SUBMITTAL IDENTIFICATION SHEET

WEBSTER UNIVERSITY ISB
PROJECT NAME

055213-010
CONTRACTOR / CM SUBMITTAL NO.

NORTHWEST VESTIBILE RAIL

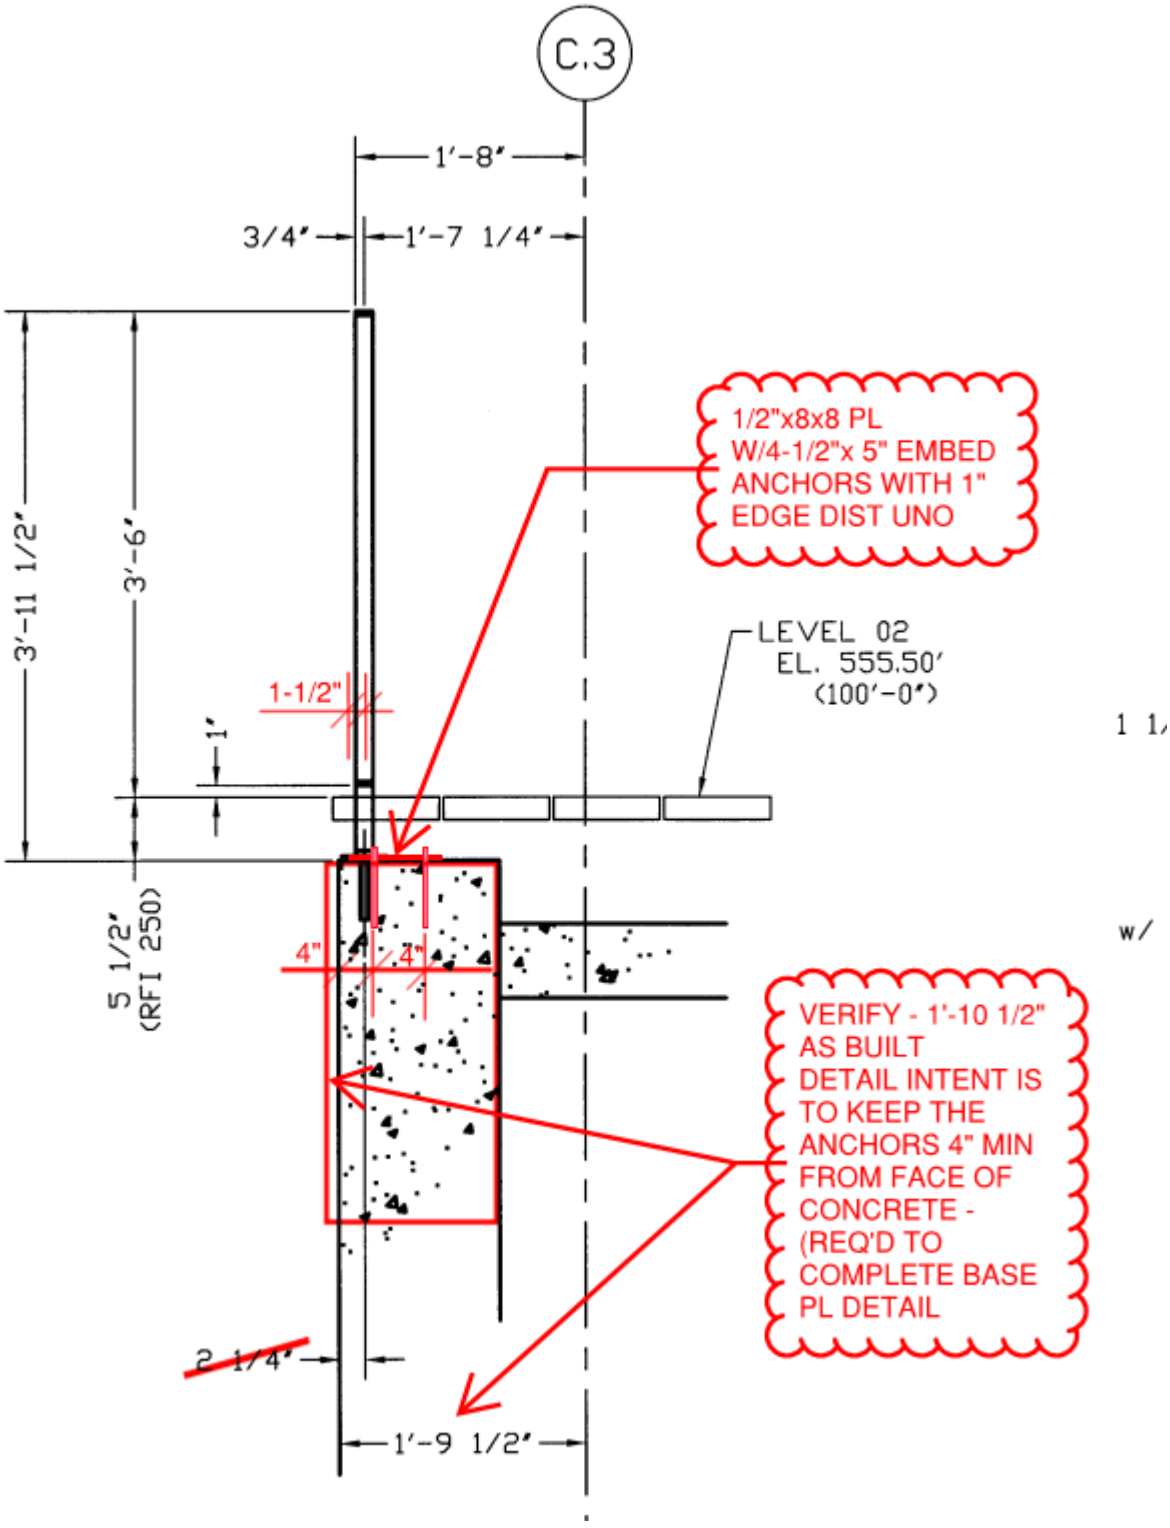
This is too close to the edge for this connection.

REVISE THE RAILING BASE CONNECTION DETAIL PER ATTACHED EMAIL DIRECTION FROM DMA (STRUCTURAL).

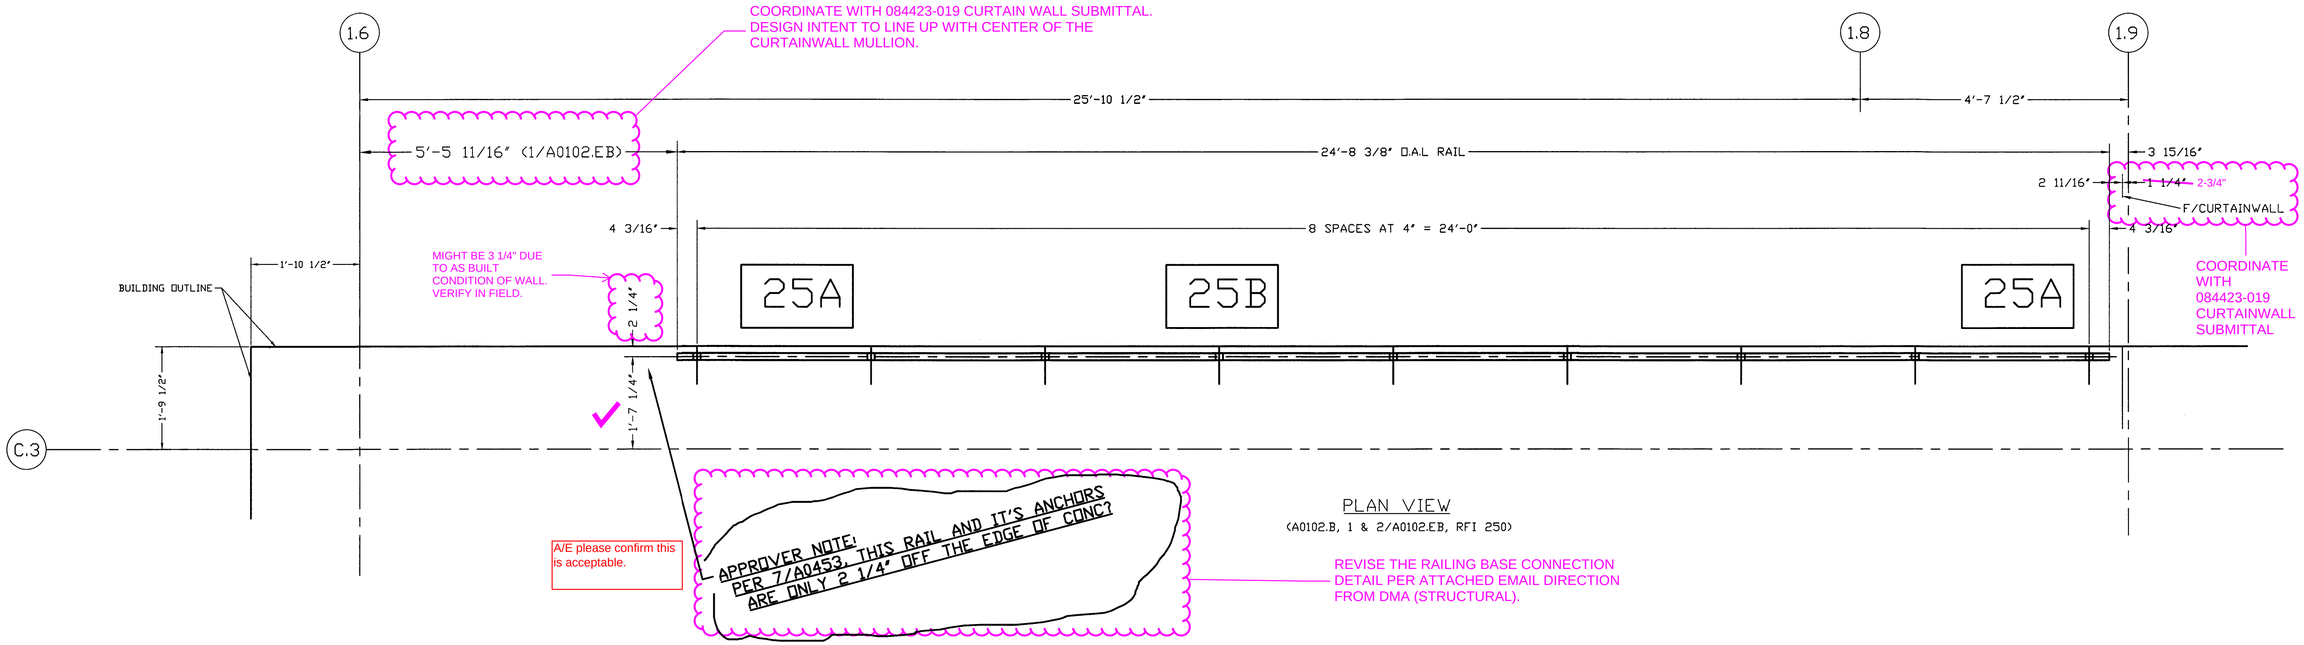
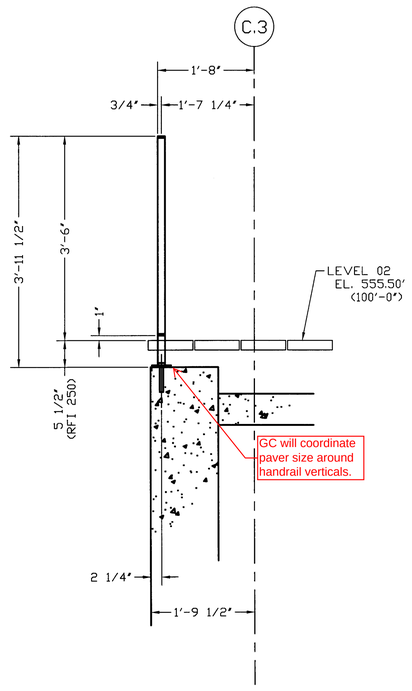
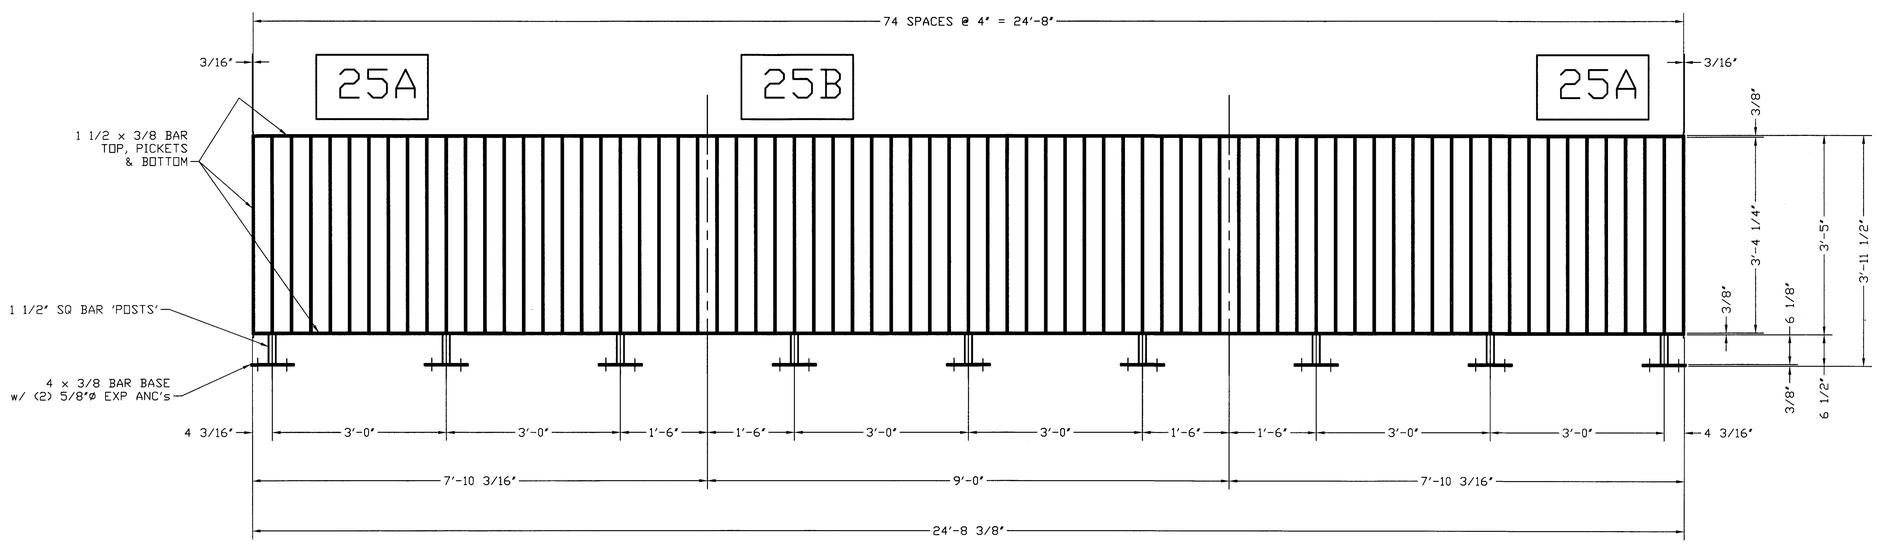
- Please note that these rails are very close to the edge of slab (see clouded comment on E6)

NORTHWEST VESTIBULE RAILS

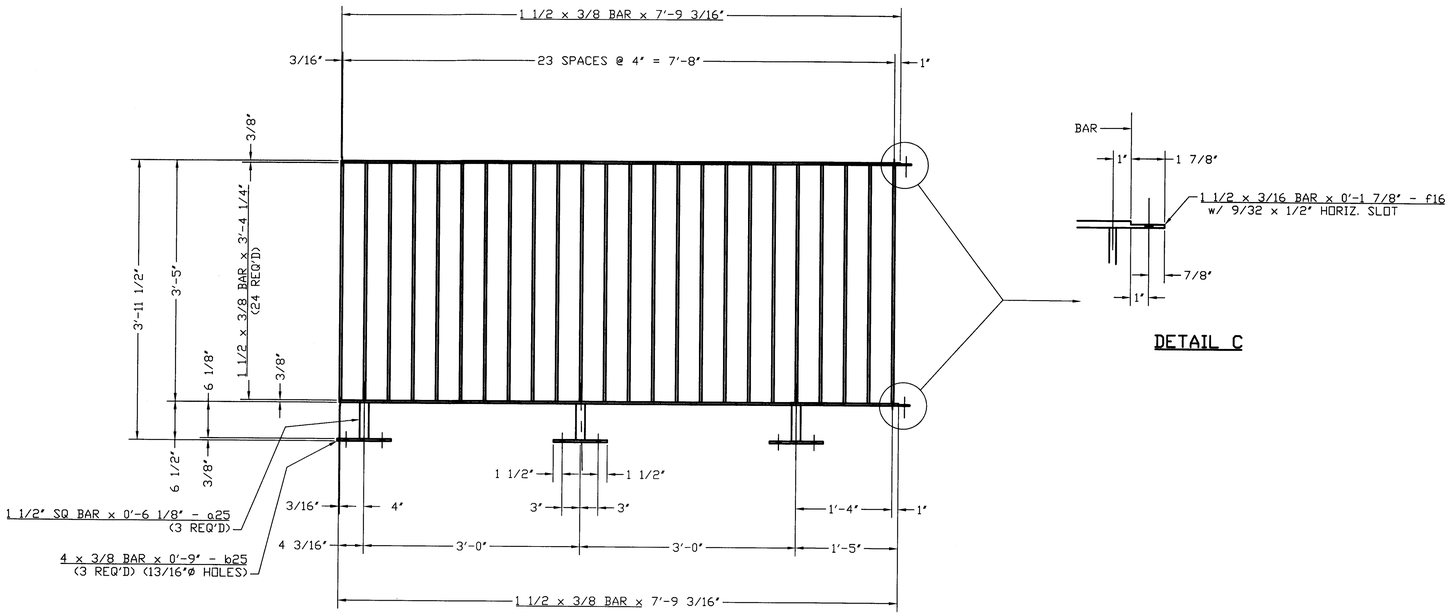
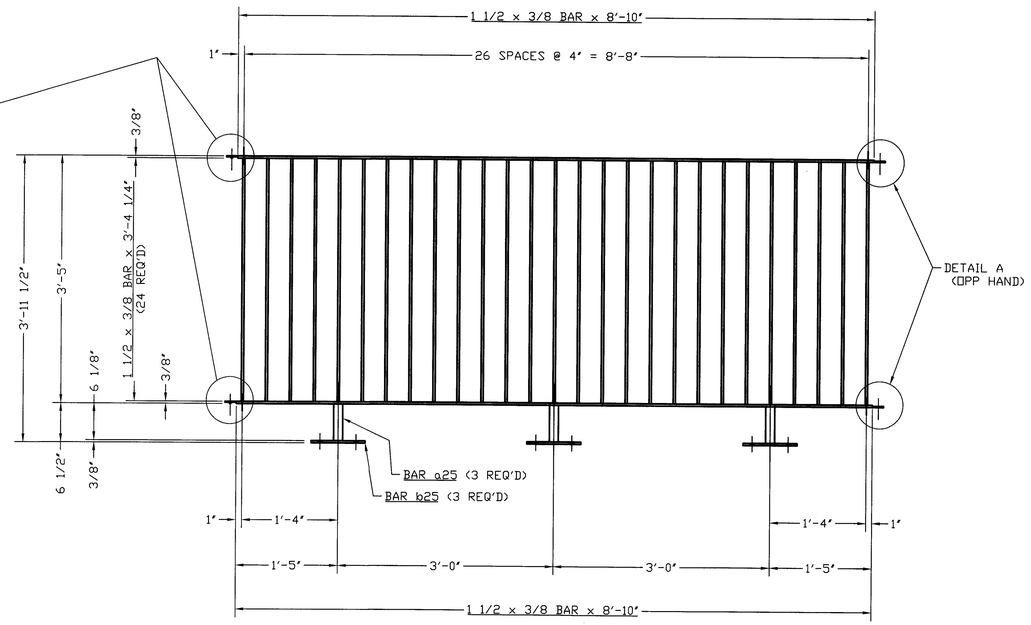
COORDINATE WITH 084423-019 FOR RAILING LENGTH.
